ADDENDUM NUMBER ONE
CHATTANOOGA PUBLIC LIBRARY – CHILLER AND BOILER IMPROVEMENTS
CONTRACT NO. L-18-001
JANUARY 25, 2019
CITY OF CHATTANOOGA, TENNESSEE

The following changes shall be made to the Request for Bids:

Public Library Chiller and Boiler Improvements

HVAC
SCHEDULES

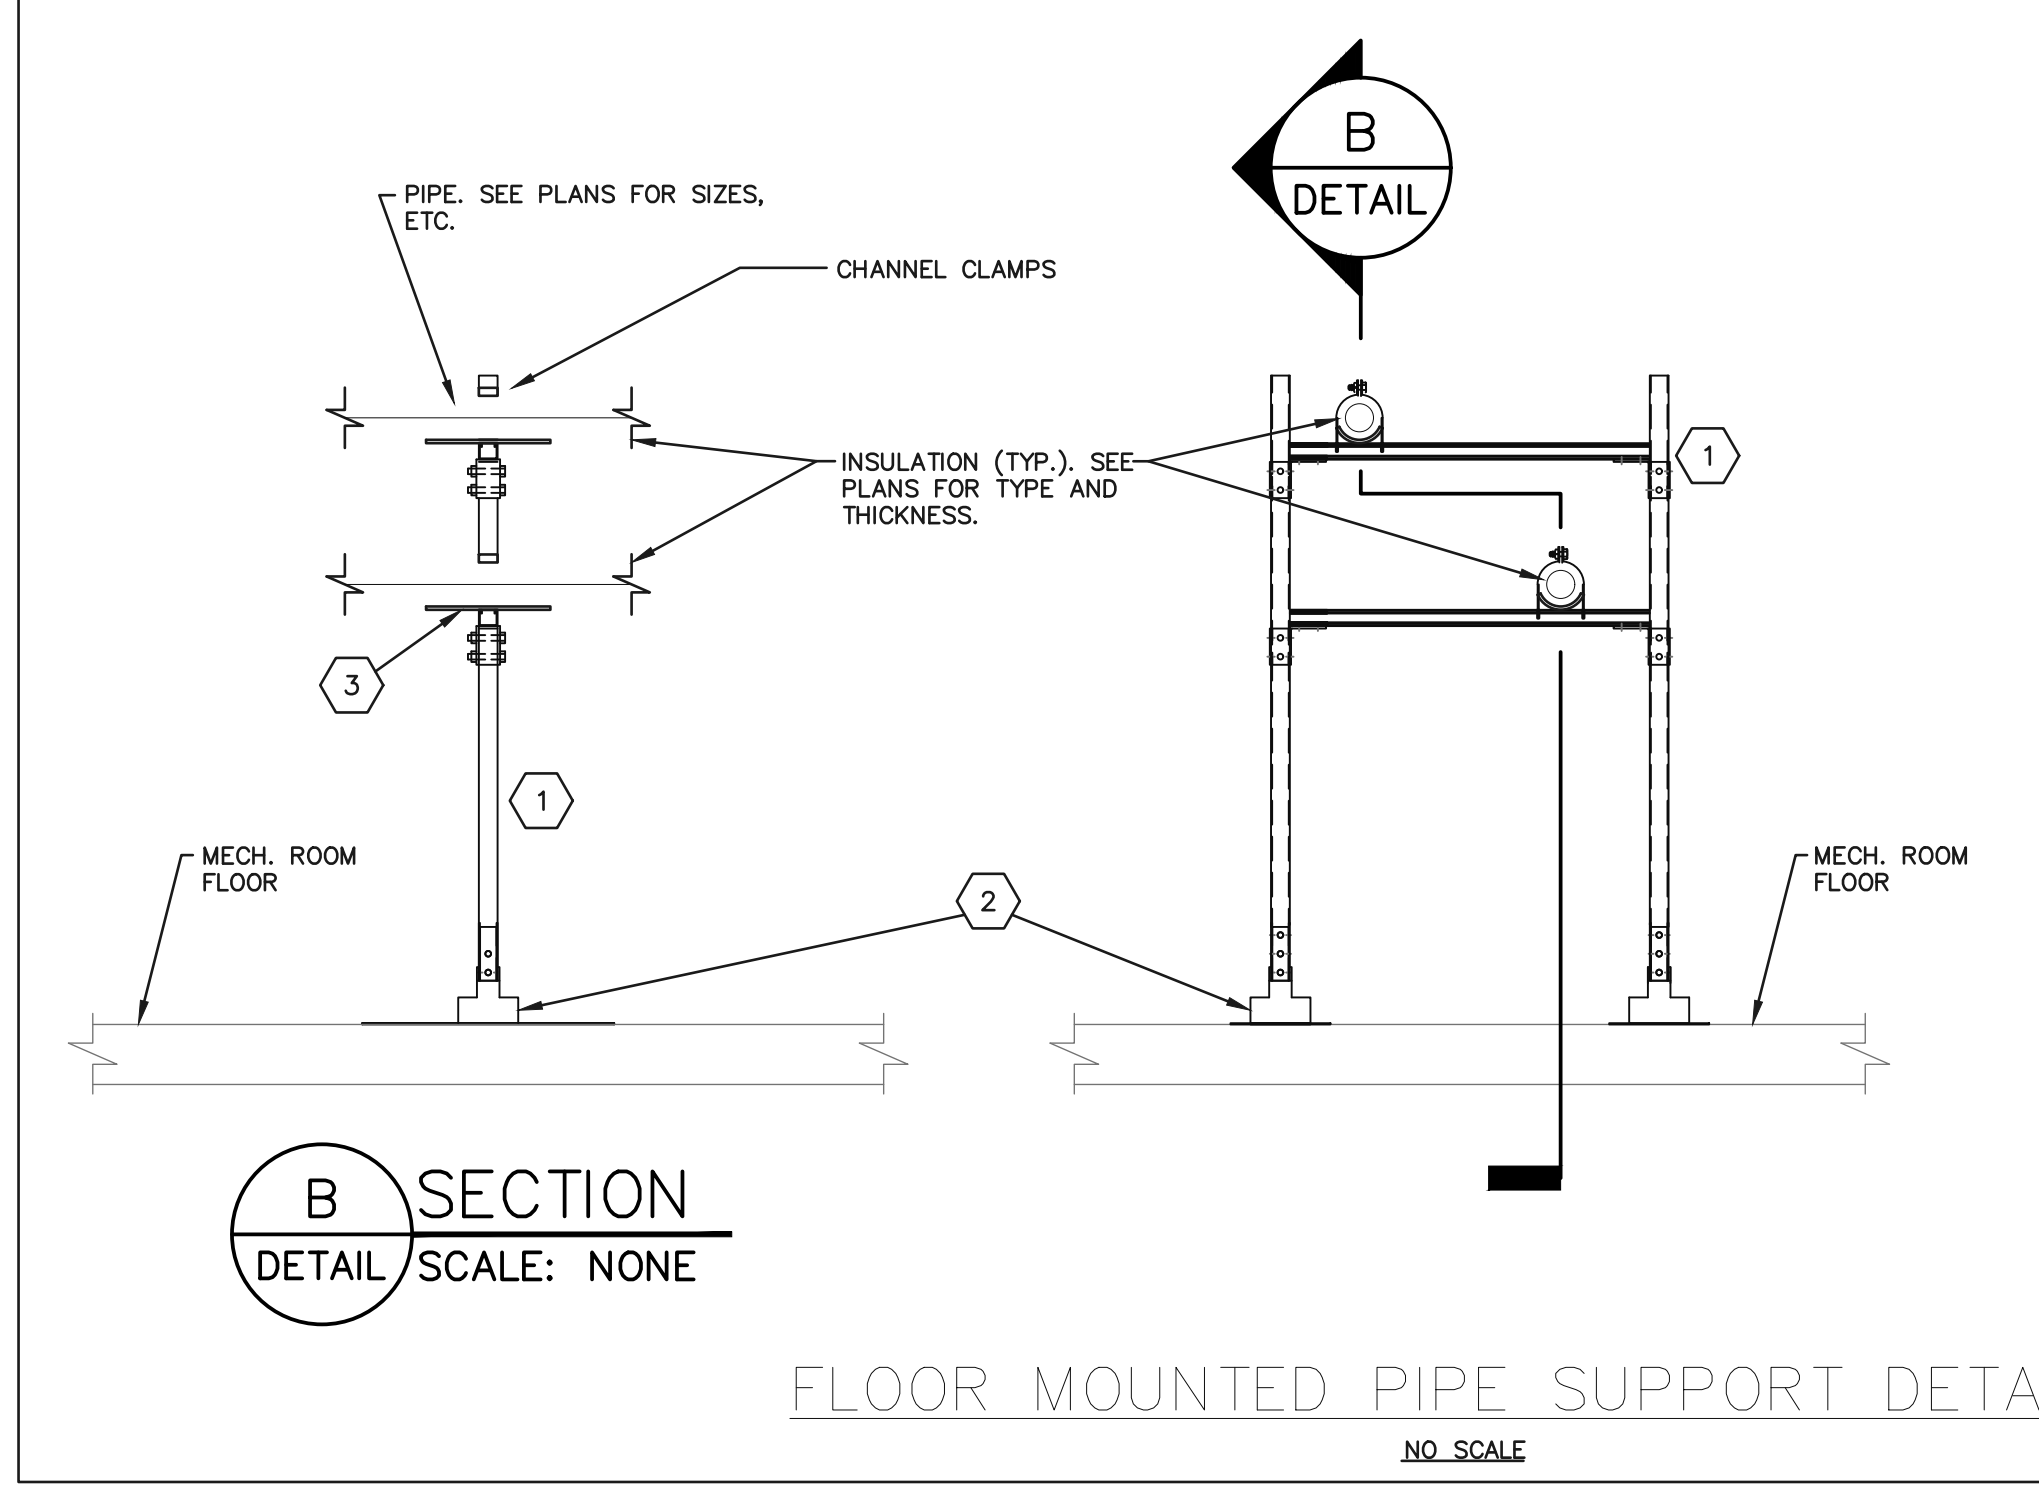
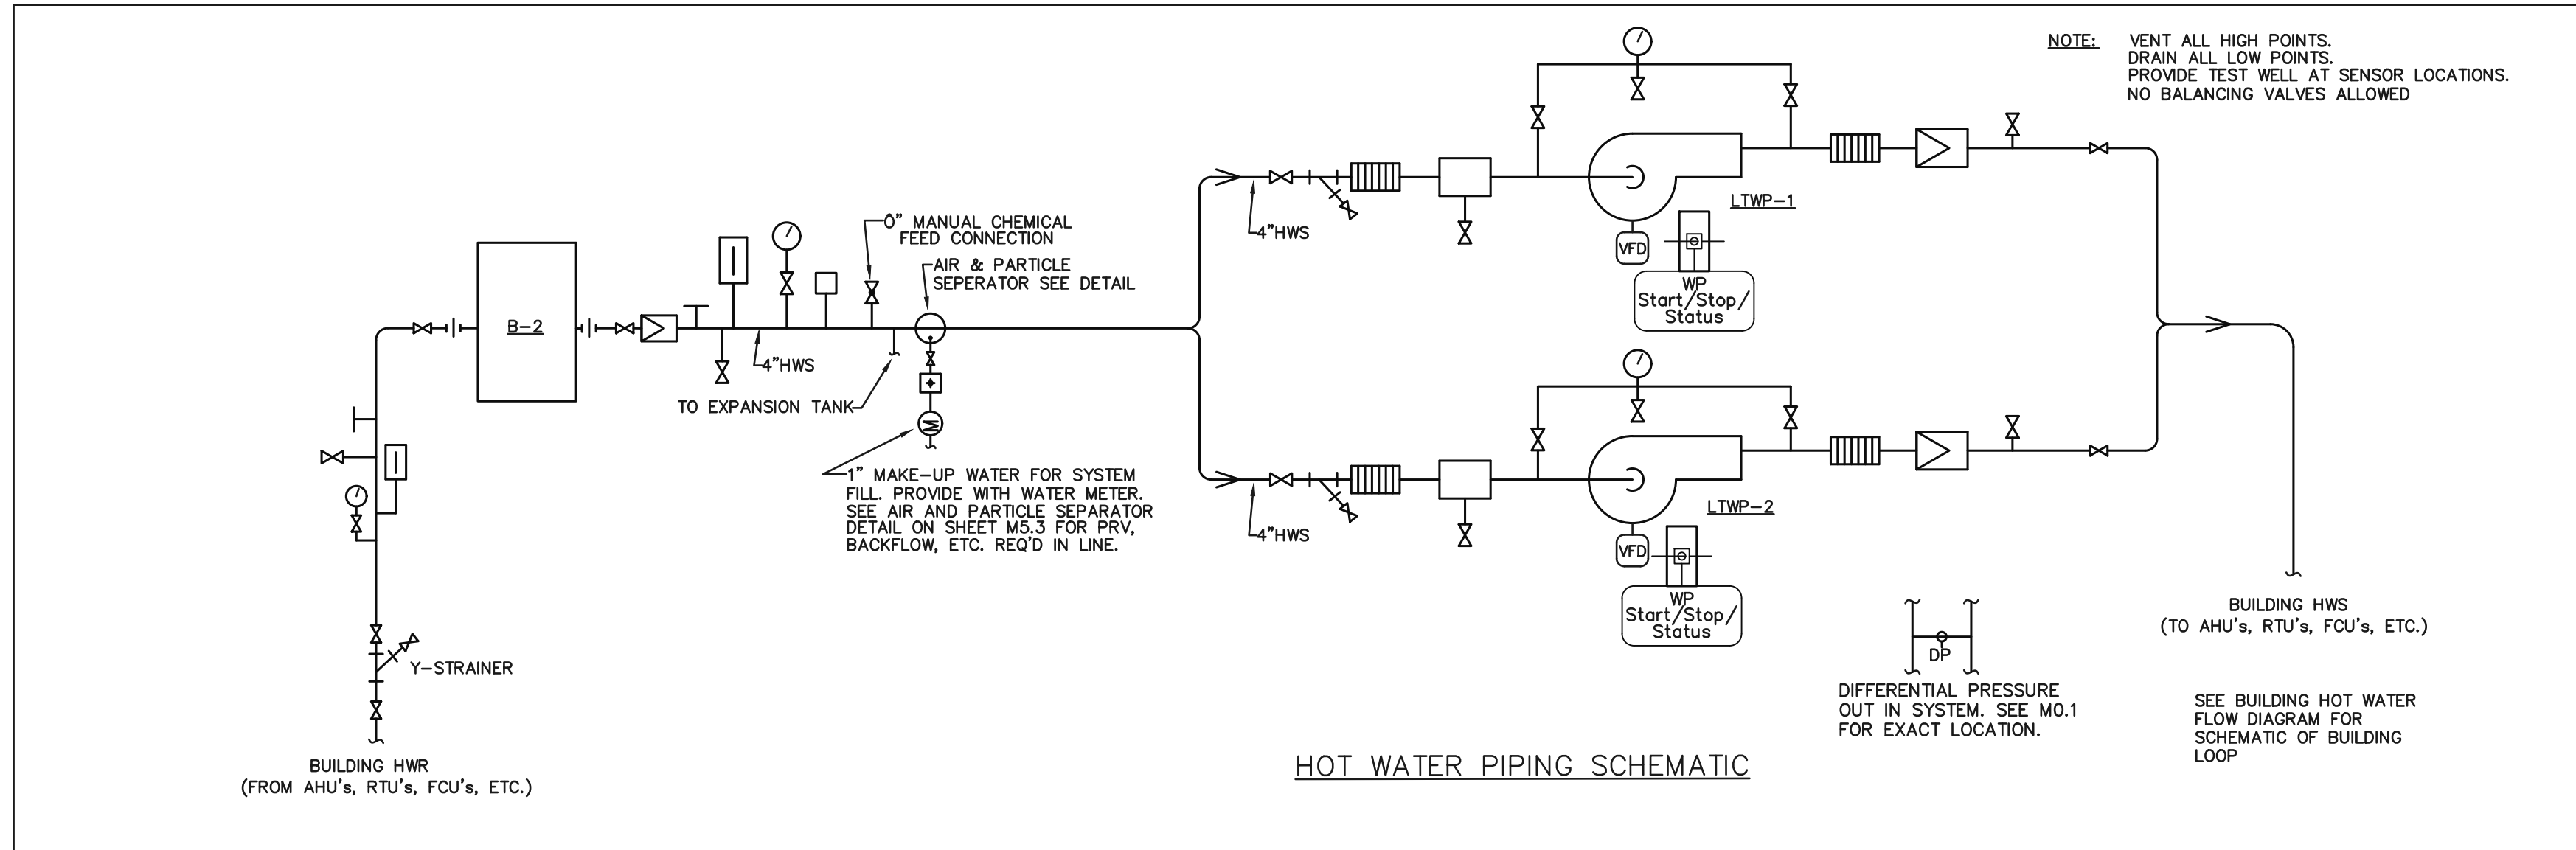
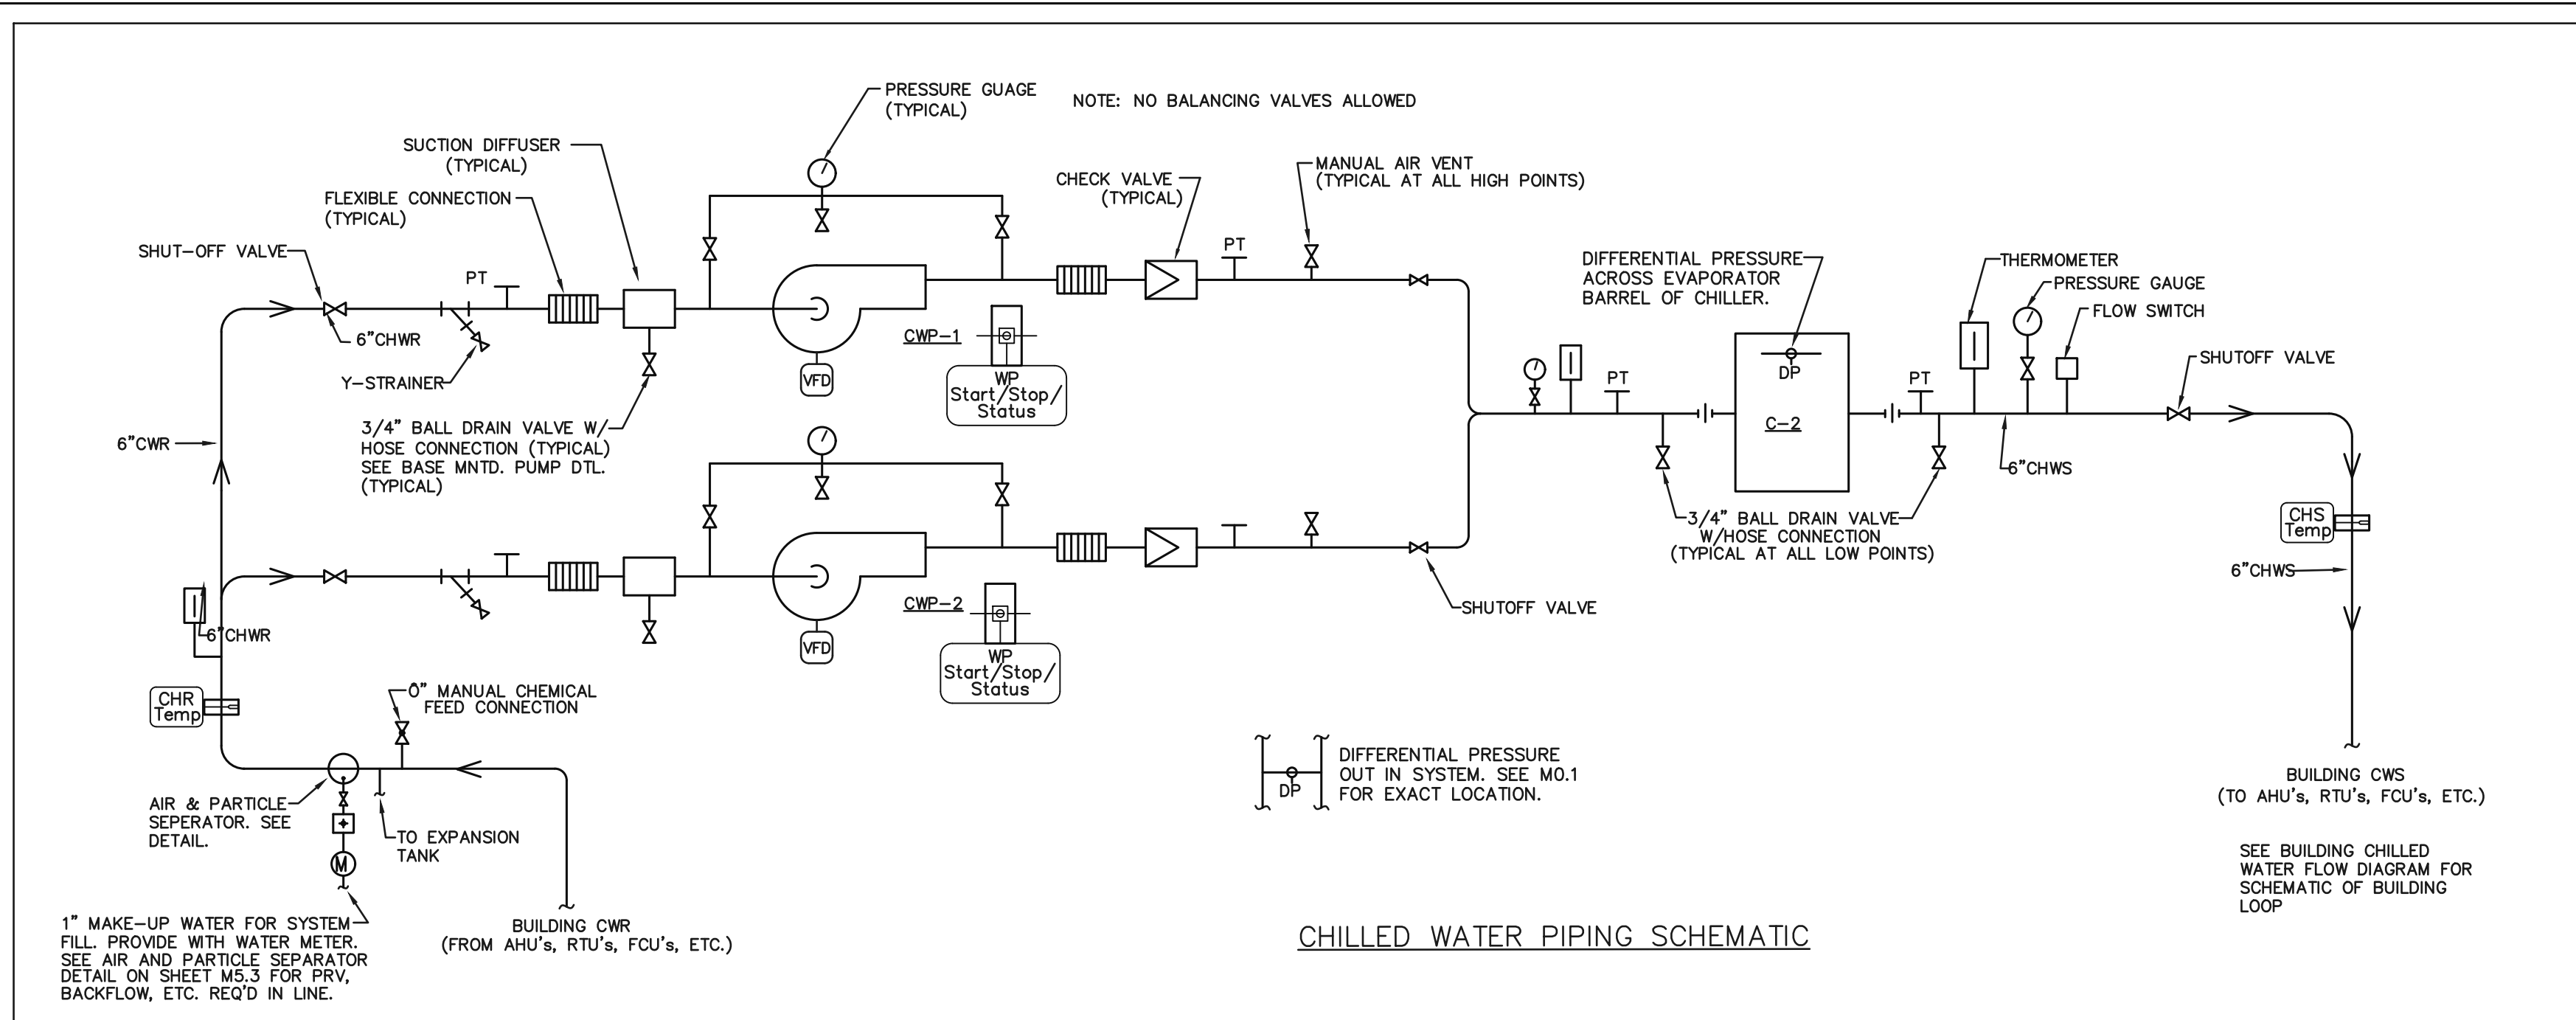
- e. Sheet M-300 HVAC Schedules is re-issued as part of this addendum and describes changes to the pumps and inertia bases.
- f. Sheet M-400 HVAC Details is re-issued as part of this addendum and describes changes to the pump bases.
